Conditional Gateway Certificate Bylong Coal Project

Report by the Mining & Petroleum Gateway Panel to accompany a Conditional Gateway Certificate for the Bylong Coal Project

15 April 2014

Figure 4. Equine CIC within the Project Boundary area (after Hansen Bailey, 2014)

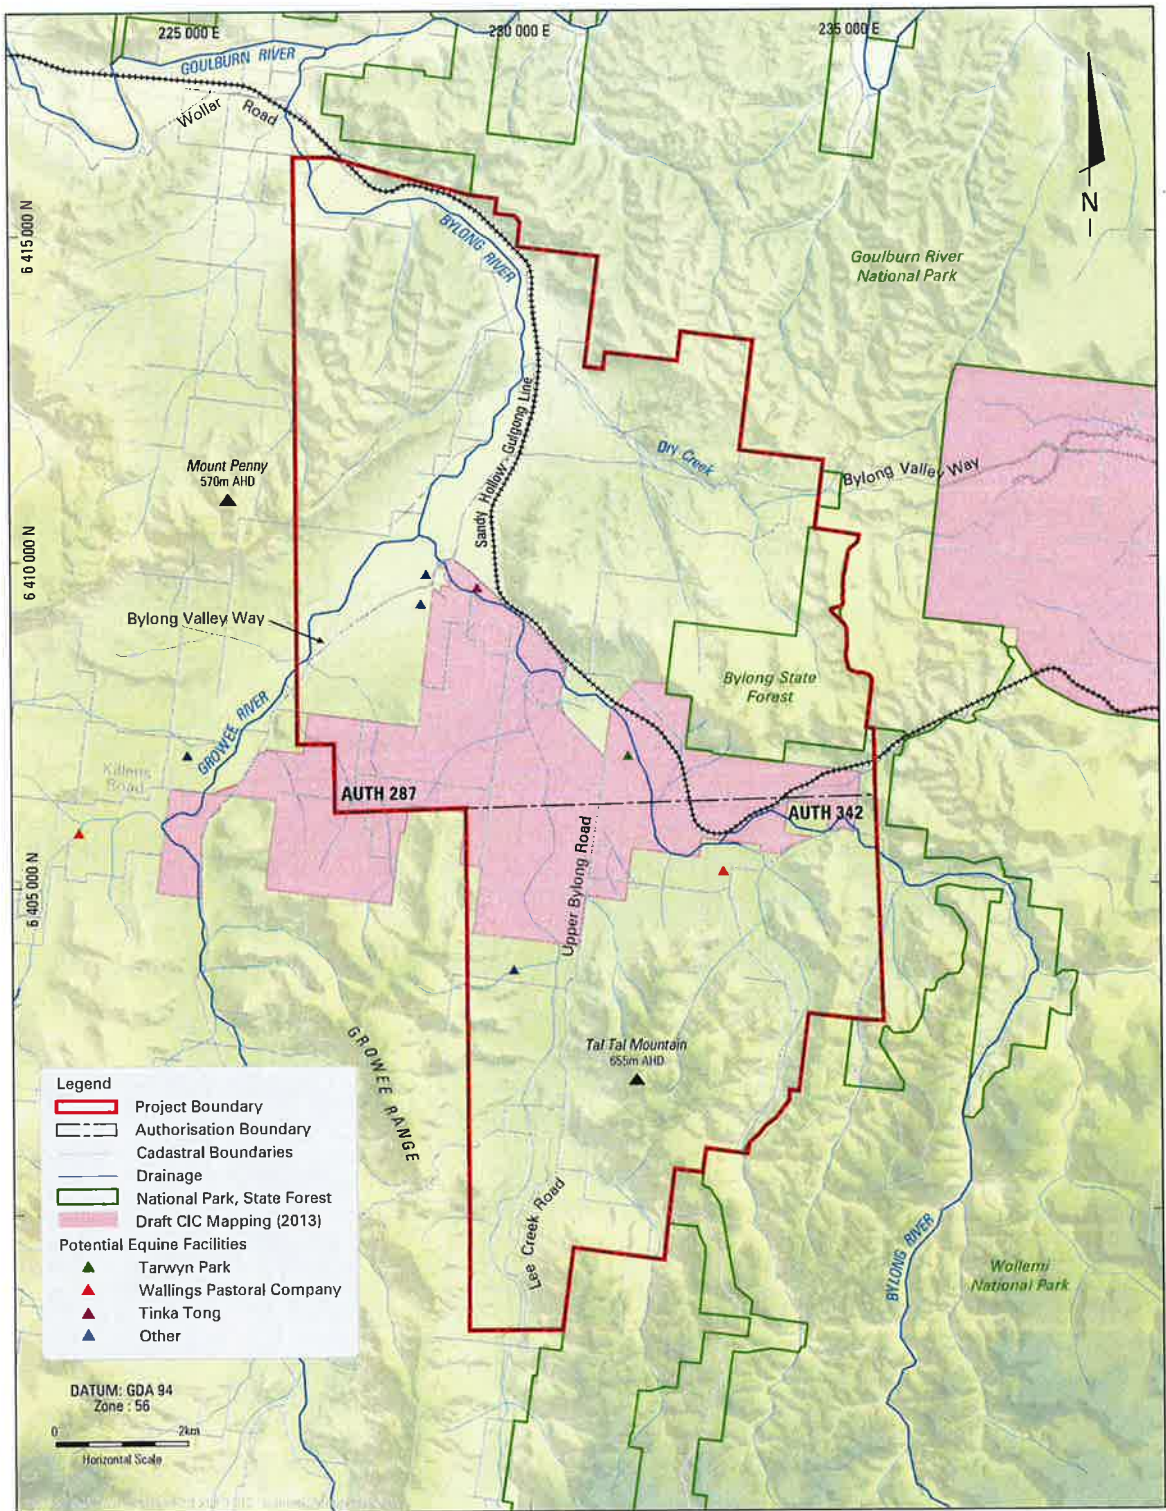
With regard to Equine CIC land, Hansen Bailey (2014) proposes that there are errors in both the DP&I (2012a) and Mining SEPP Critical Industry Cluster Land Map Sheet CIC_001 mapping. Hansen Bailey (2014) concludes that there is no Equine CIC land relevant to Project and therefore, no requirement for assessment of potential impacts.

Within the Project Boundary, the strategic regional land use plan (DP&I, 2012) indicated about 6,617 ha of Equine CIC land. In January 2014, the NSW Government verified Equine CIC lands in the Upper Hunter region and this revised mapping indicates 1,933 ha of Equine CIC land within the Project Boundary, as confirmed by Hansen Bailey (2014).

- The Applicant did not lodge a Verification Application to Planning & Infrastructure;
- The Interim Verification Protocol is now obsolete and can no longer be used; and,
- Verification of Equine CIC land was never a component of the Gateway process.

Figure 5. Verified BSAL (2,366 ha) within the Project Boundary area (after Hansen Bailey, 2014)

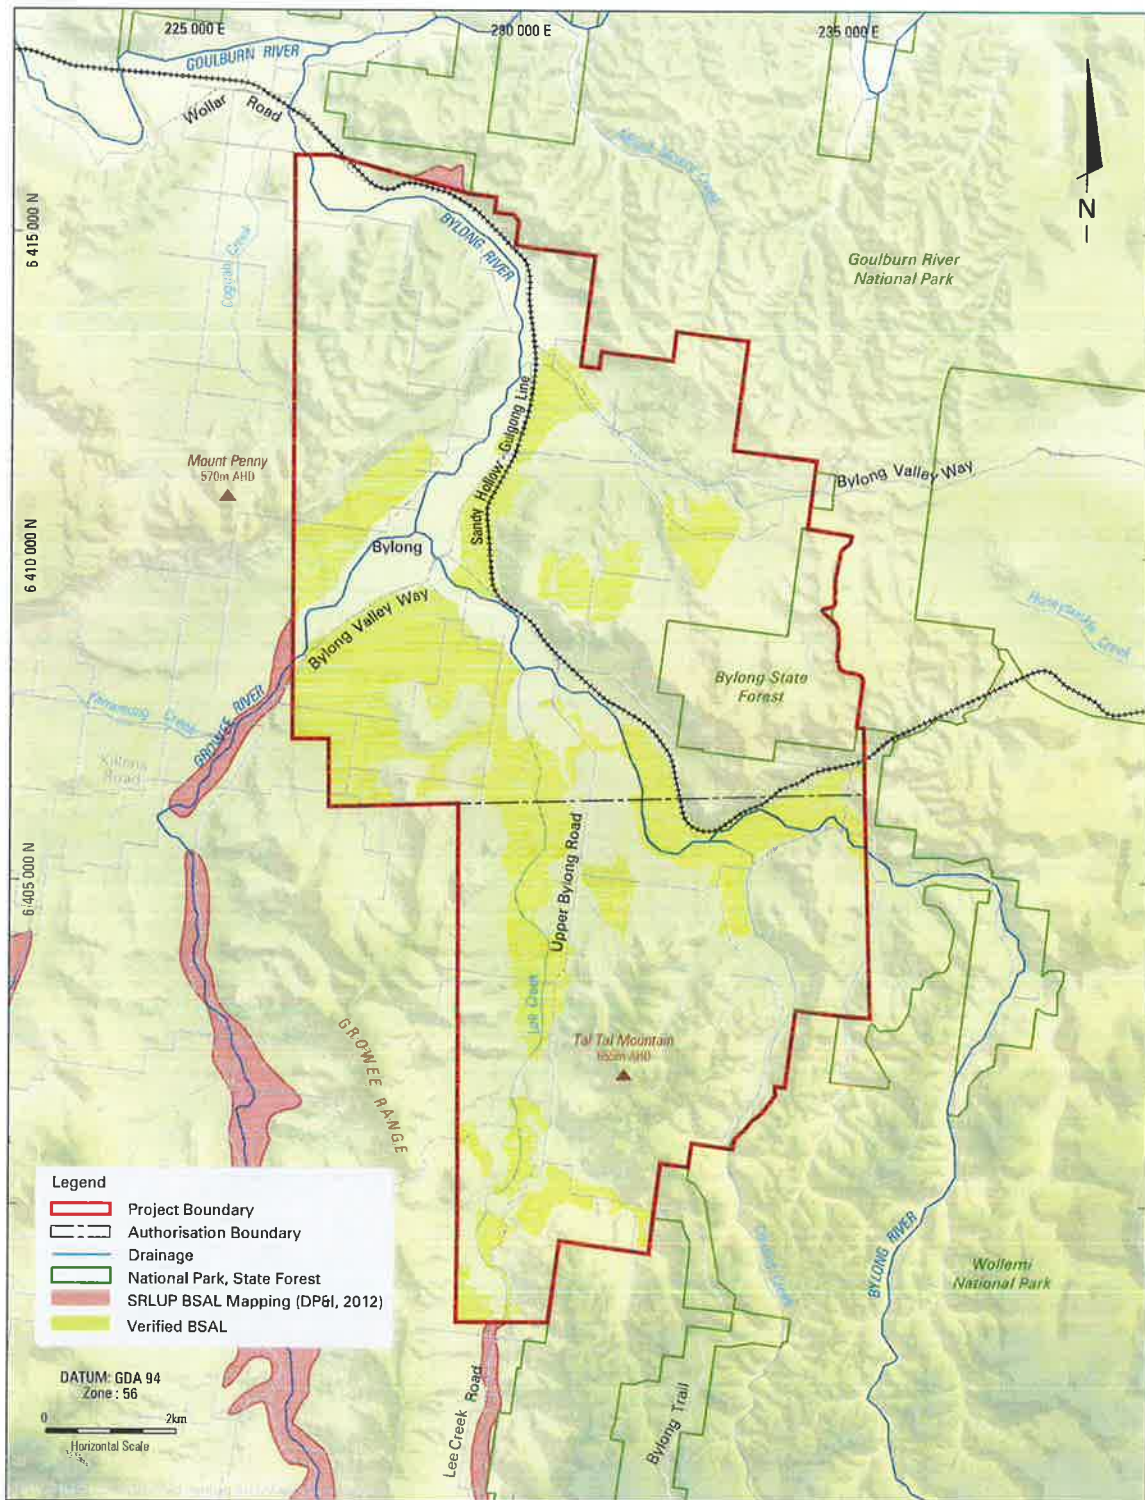
According to Hansen Bailey (2014) however, there is 2,366 ha of verified BSAL soils within the Project Boundary (Figure 5) and 367 ha of these will be impacted by the Project (Table 1). Inconsistently, SLR (2013a and 2013b) and Barnett (2013) discuss potential impacts to 401 ha of verified BSAL soils.

The Applicant verifies 2,366 ha of BSAL within the Project Boundary but provides insubstantial information of how verified BSAL within the Project Boundary but outside of planned disturbance areas is impacted or how potential BSAL outside of the Project Boundary is potentially, indirectly impacted by the Project.
